TOWN OF AURORA
ADDITIONAL ITEMS
FOR HERITAGE ADVISORY
COMMITTEE MEETING

RE: Additional Information to Heritage Advisory Committee Report No. HAC15-007 -
32 Wellington Street East, Final Disposition of the "David W. Doan House"
Designated under Part IV of the *Ontario Heritage Act*

Re: Peer Review of Structural Engineering Report
32 Wellington St. East, Aurora, Ontario

32 Wellington St. East
Aurora, Ontario
Peer Review of Engineering Report

DEMOLIITON IN PROGRESS AT 32 WELLINGTON STREET EAST. DEVELOPER HAS ADEQUATELY UNDERPINNED AND SHORED AS PER THE PERMIT REQUIREMENTS.

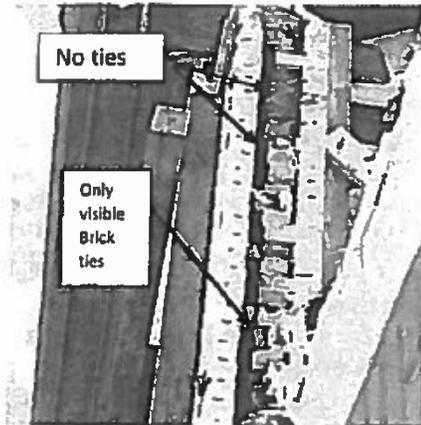
The owners have adequately underpinned and shored the structure as required. The existing load bearing veneer and outer façade veneer was found to be very soft. It is our opinion that the veneer would not be suitable in meeting today's standards for load bearing masonry or veneer. The ties between the load bearing veneer and the outside cladding is hazardous and does not meet the requirements of Table 9.29.5 (masonry ties). Because of the noted defects in the exterior wall we believe the existing masonry should be replaced using the existing materials for the façade only. The backup load bearing masonry should be replaced with 200 mm masonry block. On this basis we recommend removal and reconstruction of the exterior façade of 32 Wellington Street East.

New cracks have appeared in the exterior façade. May have resulted from inadequate ties of a result of the demolition procedures.

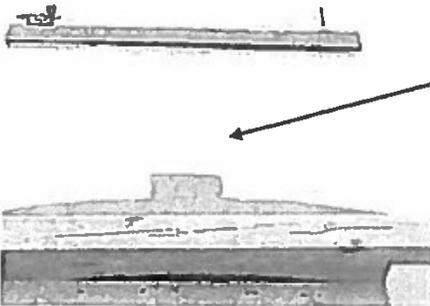
The existing load bearing veneer is in poor condition. The veneer is not adequately tied to act as load bearing masonry. The connection between the two (2) Inner Wythes is not continuous or solid. We are of the opinion that the wall does not meet the standards as a load bearing condition. As well, the outer façade is out of plumb because it is not adequately tied to the inward wall. Ties exceed the spacing of OBC Table 9.20.5.
